BULLETIN No. 188

NEW CIRCUIT BOARD AND FUSE FOR THE R-1473 CREDIT UNIT

F-10344 SWITCH CIRCUIT ASSEMBLY

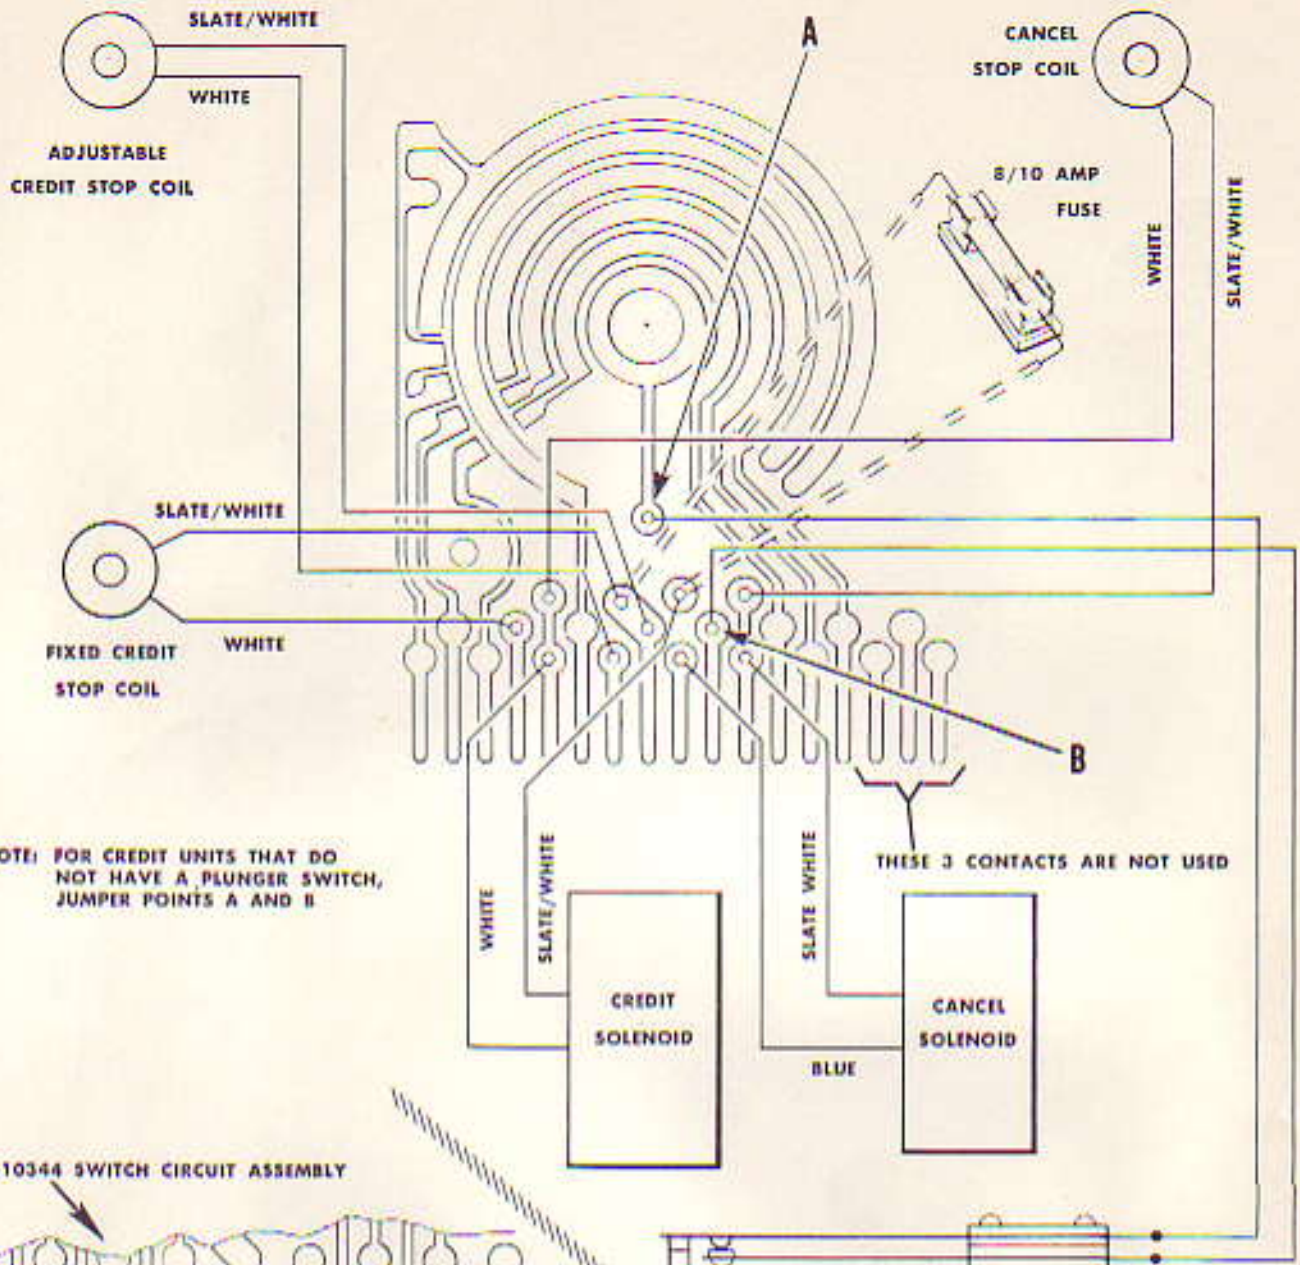
A recent change in the R-1473 credit unit incorporates an 8/10 amp. slow blow fuse on the switch circuit assembly. This fuse protects the main credit solenoid in case a light weight or bent coin lodges on the coin switches.

This change requires a new switch circuit board assembly (part No. F-10344) which replaces and supersedes earlier versions of this part.

The new switch circuit board can be used in all versions of the R-1473 credit unit. The following sketches show the proper connections.

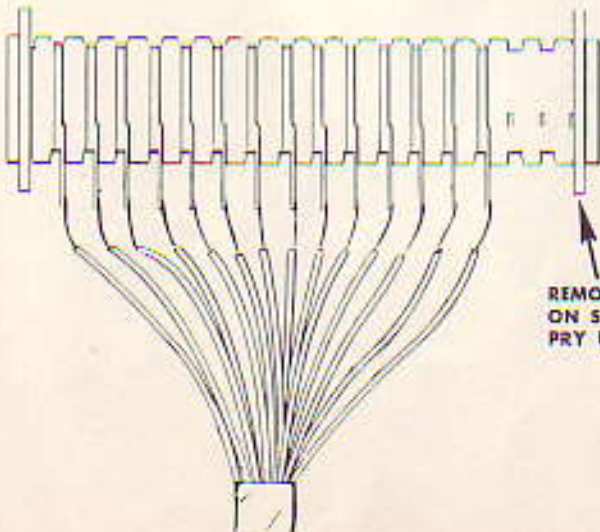
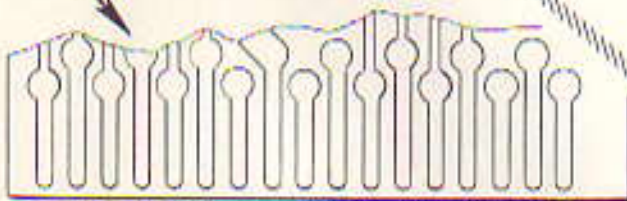
REMOVE THIS GUIDE
ON SHORT EDGE CONNECTORS
PRY UP CLIPS TO REMOVE
